SB, ECU Harness, FS7000D/DL, 2026-01

FS 7000 D/DL

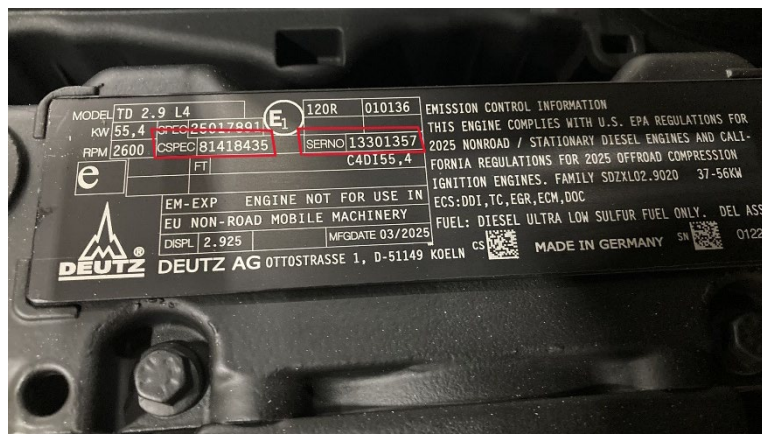
A new ECU is introduced to the Deutz engine to obtain the new regulation for the CE machines. This new ECU is also introduced to machines not affected by this new regulation, but where the software has the same setup as the old ECU. The contactors on the ECUs are of the same model, but the pin-out differs. This can lead to severe damage to the ECU if the wrong harness is attached to the wrong model of ECU.

Harness 590422101 is replaced by 593111001 due to wear. This is the correct harness for the "old" Tier4 engines.

Harness 597037101 is released for:
Stage 5 (CE std) Engines SN 1409826001
Tier 4 (US std) Engines SN 1410735001

Be very thorough when ordering a new harness and be sure of the machine's serial number or CSPEC number.

Old engine/ECU has 81415111

New engine/ECU has 81418435

The information is to be found on the top of the engine.
